RB148-04/05

R505.1.1, R505.1.3, R505.2, Table R505.2(3), Figure R505.2(3), R505.3.2, R505.3.6, Table R505.3.2(1), Table R505.3.2(2) and Table R505.3.2(3)

Proponent: Jonathan Humble, representing the American Iron and Steel Institute

**FIGURE R502(3)
FLOOR JOIST WEB HOLES**

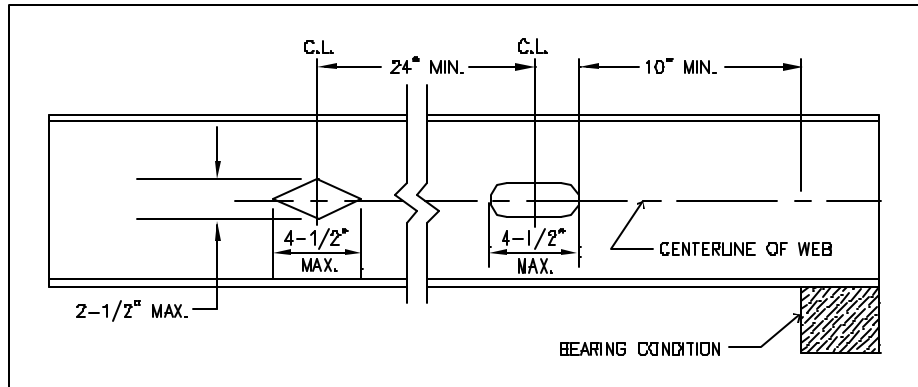
Delete existing Figure R505.2(3) and substitute as follows:

Modifications are proposed to the web hole provisions by deleting the text, table and figure and replacing it with language and a new figure consistent with the ANSI/COFS/PM-2001. The differences between the IRC-2003 and the proposal are that the proposal for Section R505.2 lists the requirements in text form (thus eliminating the need for a table), and that proposed Section R505.3.6 contains additional provisions to recognize limitations when a design professional is necessary or when the member is to be replaced.

1. Holes shall conform to Figure R505.2(3).
2. Holes shall be permitted only along the centerline of the web of the framing member.
3. Holes shall have a center-to-center spacing of not less than 24 inches (610 mm).
4. Holes shall have a web hole width not greater than 0.5 times the member depth, or 2-1/2 inches (64.5 mm).
5. Holes shall have a web hole length not exceeding 4-1/2 inches (114 mm).
6. Holes shall have a minimum distance between the edge of the bearing surface and the edge of the web hole of not less than 10 inches (254 mm).

Framing members with web holes not conforming to the above requirements shall be patched in accordance with Section R505.3.6 or designed in accordance with accepted engineering practices.
